Amendments to the Drawings:

REMARKS/ARGUMENTS

FIG.8

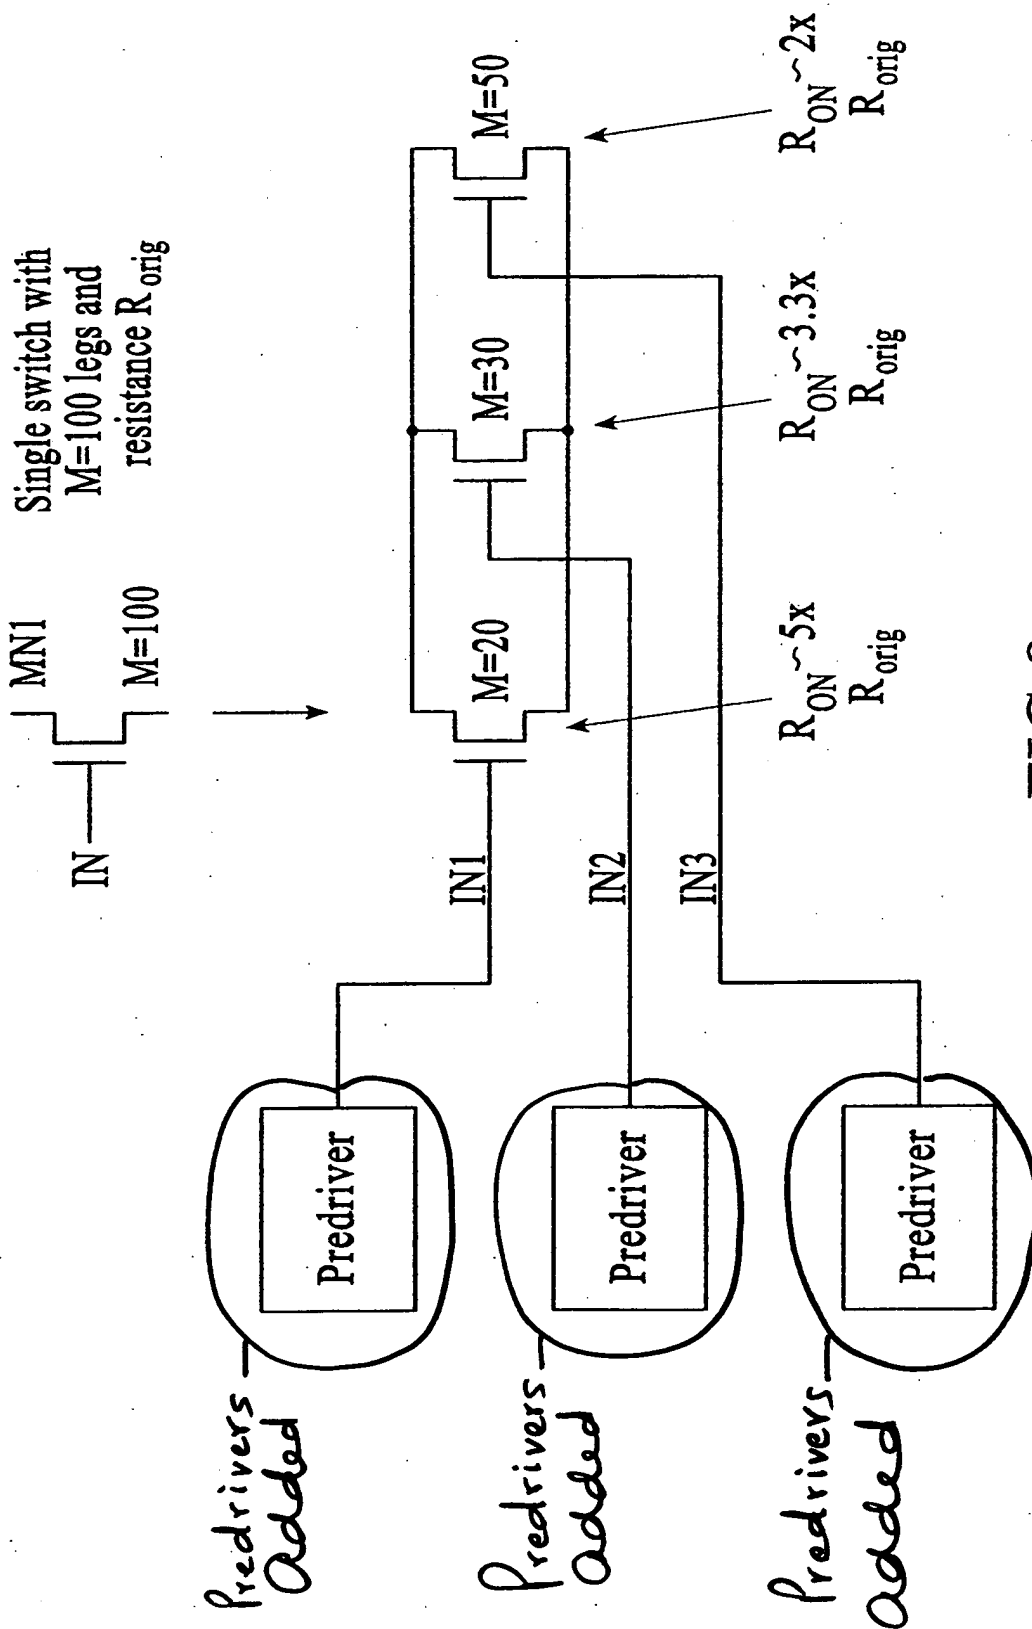
The attached sheet of drawings includes changes to Figure 8. Replacement sheets for Figures 1-7 are also included.

Applicants are submitting drawing corrections of Figure 8 to comply with objections noted by the Examiner. Specifically, predrivers coupled to control electrodes of the transistor groups are now included. A full set of Figures 1-8 on 7 replacement sheets are included. Support for the drawing corrections can be found in the specification. No new matter has been added.

Predrivers
added

Predrivers
added

Predrivers
added
